New Replacement Part for SF56 Series Micro SIM Card Connector

This is a formal notification for the new replacement part for the SF56 Series.

Phasing Out Part No. Replacement Part No.
SF56S006V4A → SF56S006V4B

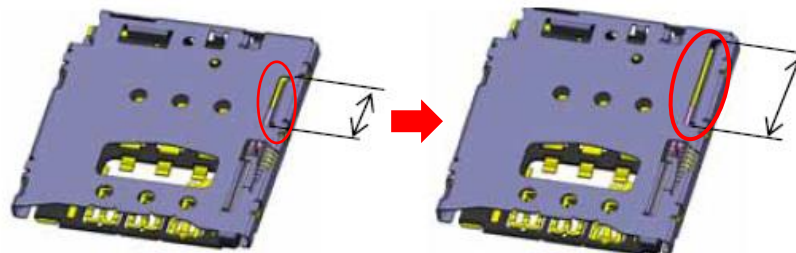
A revised version of the SF56 connector has been released with a minor design change to improve the reliability of the connector when a non-compliant SIM card is inserted. The reliability improvement has been accomplished by increasing the length of the coil spring guide. Please see the diagram below for more details on the change.

The footprints are compatible, so the new version can be used as a drop in replacement. Please promote the B type to any new customers, and also try to have existing customers switch to the B type. The new replacement part is now available to purchase.
